DATE: 04/11/95 JOB NO. 02070-0061
FROM: Jaff Auchterlonie
RE: Ringsby Terminal - Port of Oakland
2225 7th Street
Oakland, CA. 94607

ORIGINALS	COPIES	DATE	DESCRIPTION
1	0	04/07/95	AMMENDED WORK PLAN FOR SOIL AND GROUNDWATER ASSESSMENT

Subject: Amended Work Plan for Soil and Groundwater Assessment
Ringsby Terminals, Port of Oakland Lease
2225 7th Street
Oakland, California
GTI Project 02070 0061

| Figure 2 | Site Plan with Geoprobe Locations |

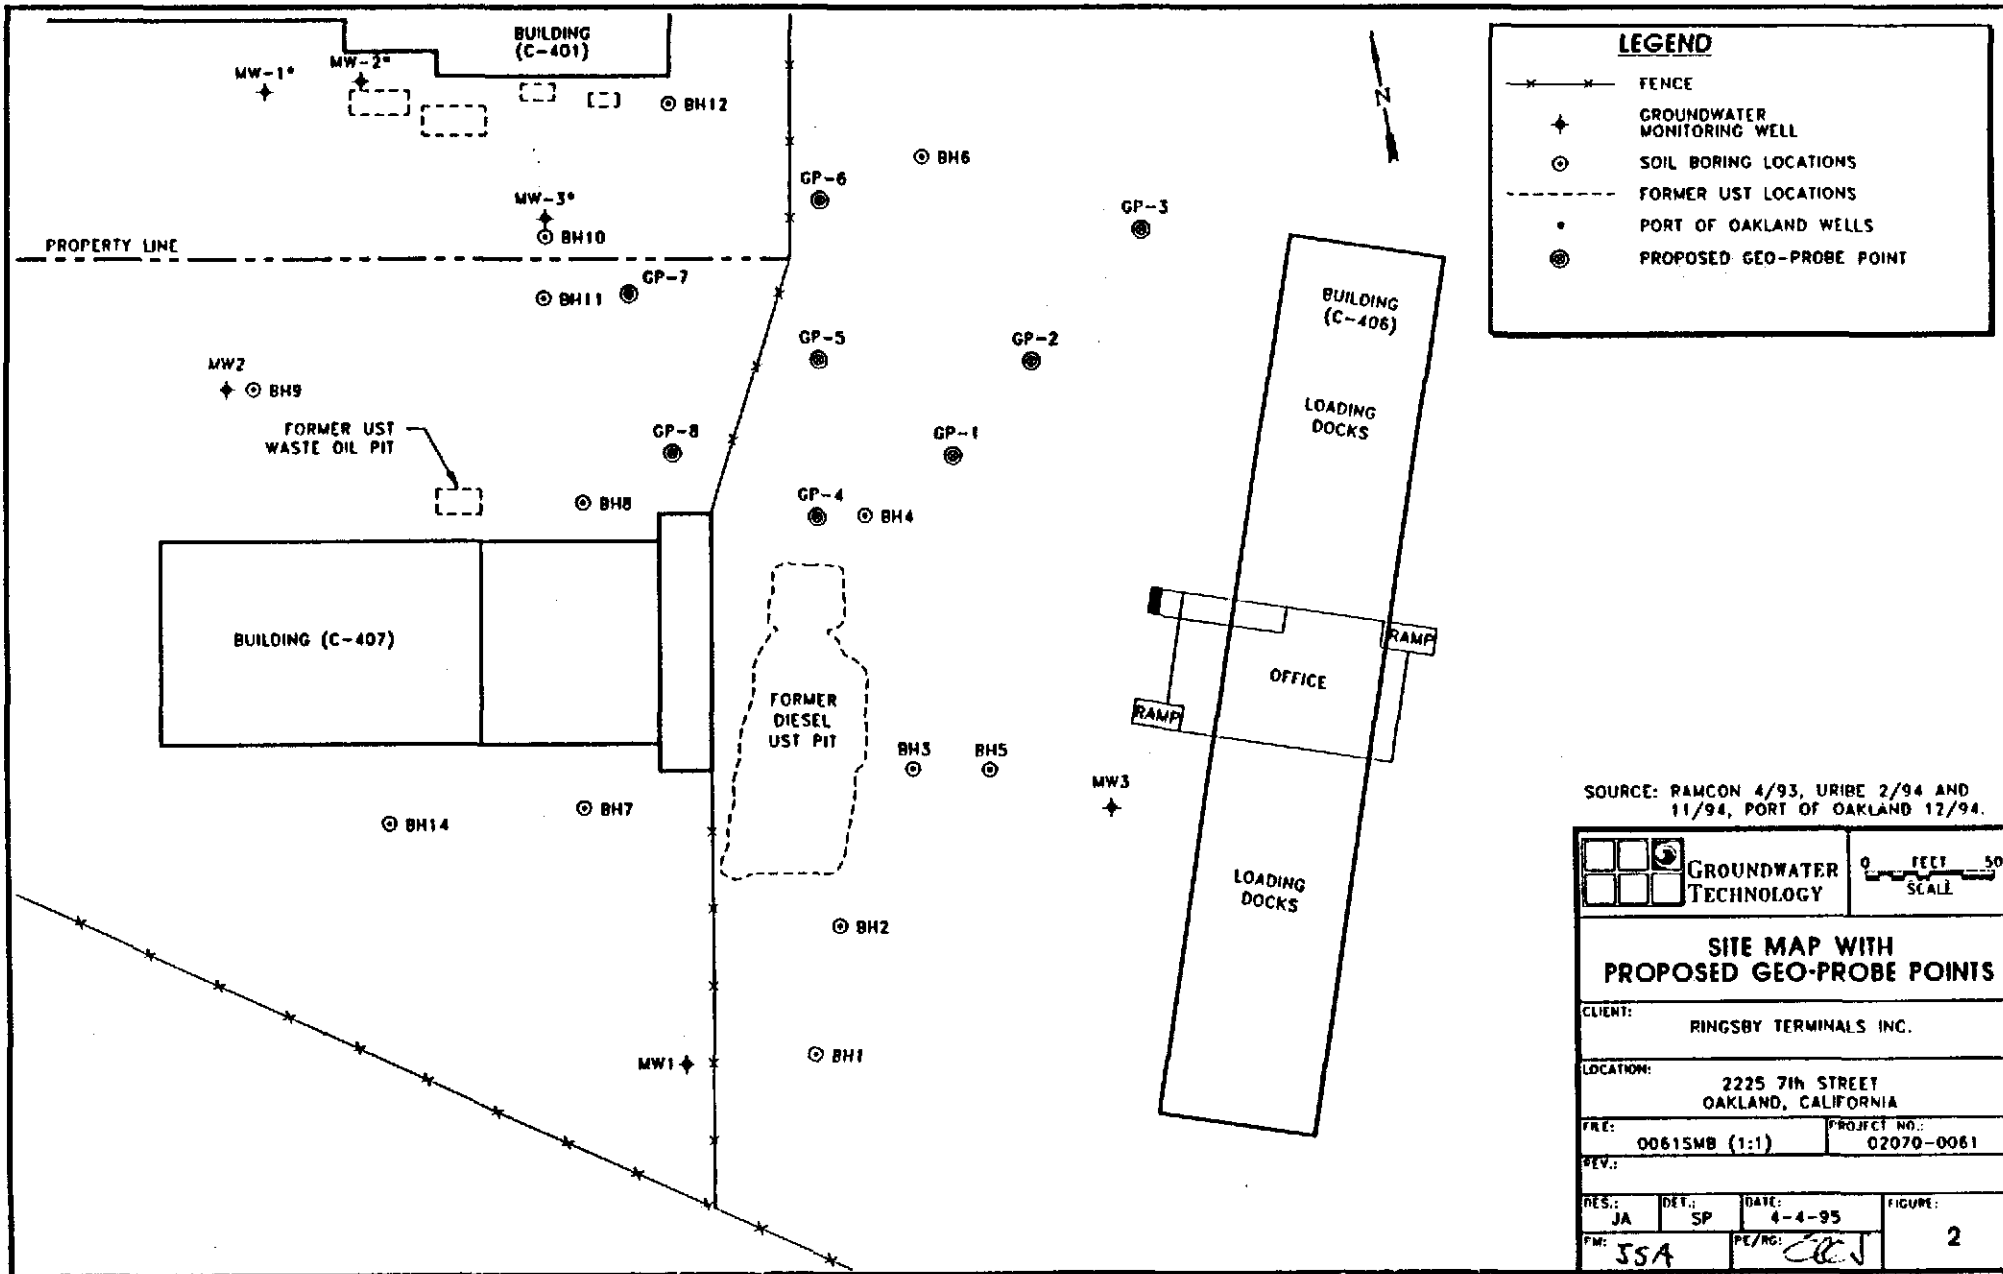
14' should be deep enough.

*at least
1 per
borehole*
